**Addendum No. 1**  
**Rock River Water Reclamation District**  
**Charles Street Sanitary Sewer Extension**  
**Special Assessment No. 132**

This ADDENDUM NO. 1, dated May 9, 2019, for the above referenced project, supersedes all contrary and conflicting information in the specifications and contract documents, which are hereby supplemented or revised as follows:

Sheet 2 of 7: LEGEND, GEN NOTES, & SUMMARY OF QTYS

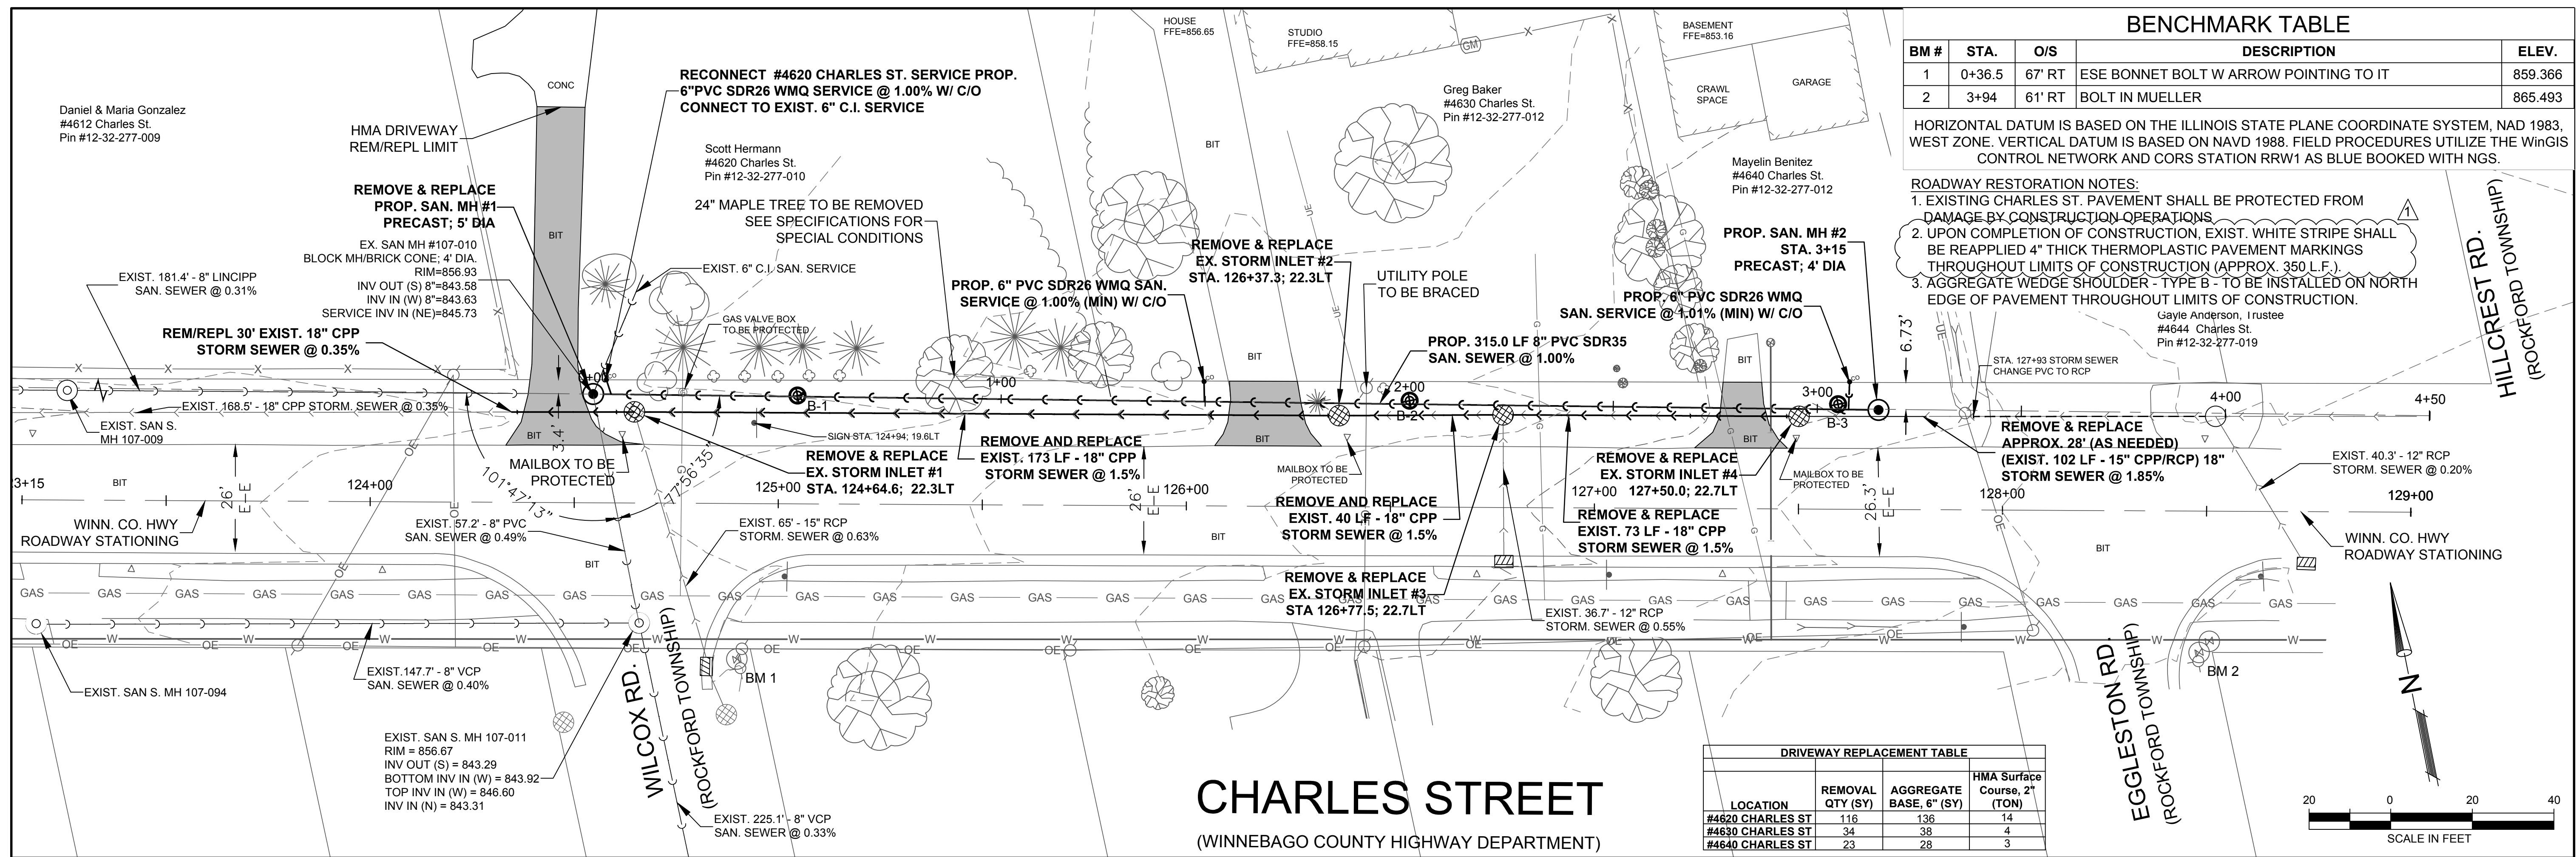
1. Summary of Quantities has been updated to reflect the revision of EPOXY PAVEMENT MARKINGS – LINE 4” to THERMOPLASTIC PAVEMENT MARKINGS – LINE 4”.

Sheet 3 of 12: PLAN & PROFILE STA 0+00 – 3+15

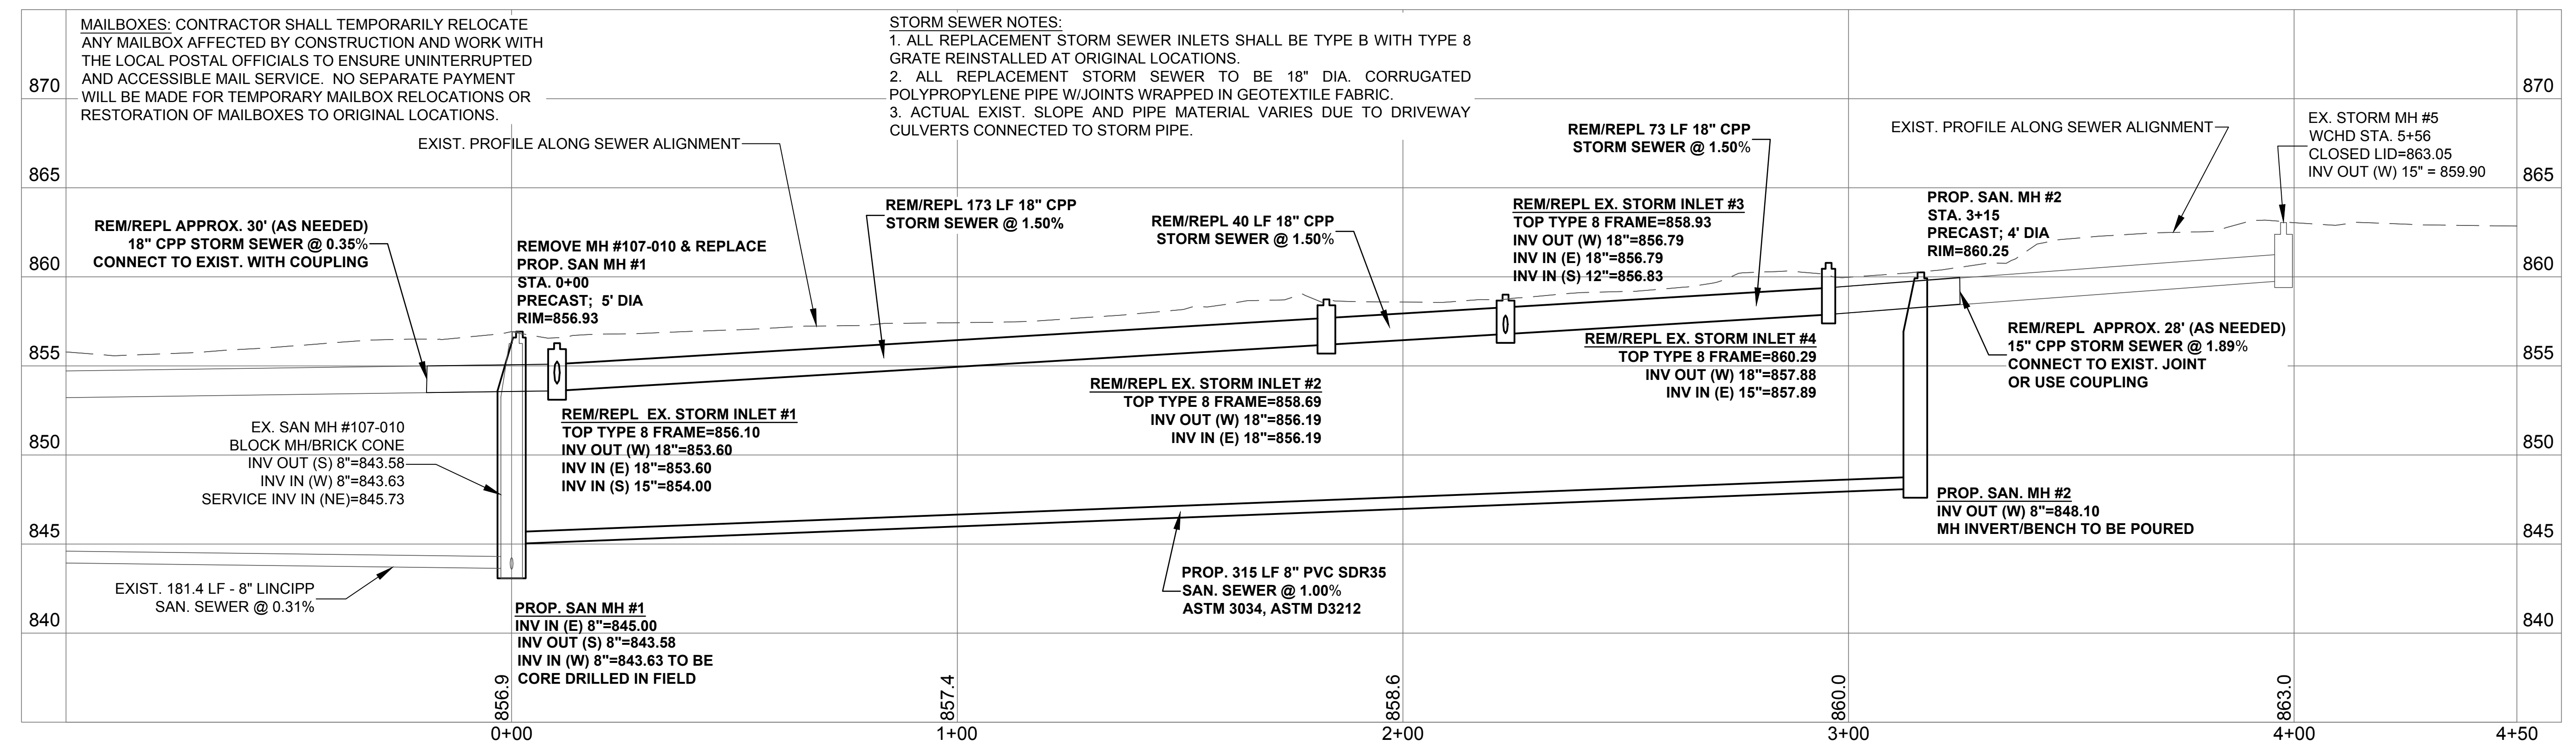
1. Roadway Restoration Notes have been updated to reflect the revision of EPOXY PAVEMENT MARKINGS – LINE 4” to THERMOPLASTIC PAVEMENT MARKINGS – LINE 4”.

- ROADWAY RESTORATION NOTES:**
- EXISTING CHARLES ST. PAVEMENT SHALL BE PROTECTED FROM DAMAGE BY CONSTRUCTION OPERATIONS.
  - UPON COMPLETION OF CONSTRUCTION, EXIST. WHITE STRIPE SHALL BE REAPPLIED 4" THICK THERMOPLASTIC PAVEMENT MARKINGS THROUGHOUT LIMITS OF CONSTRUCTION (APPROX. 350 L.F.).
  - AGGREGATE WEDGE SHOULDER - TYPE B - TO BE INSTALLED ON NORTH EDGE OF PAVEMENT THROUGHOUT LIMITS OF CONSTRUCTION.
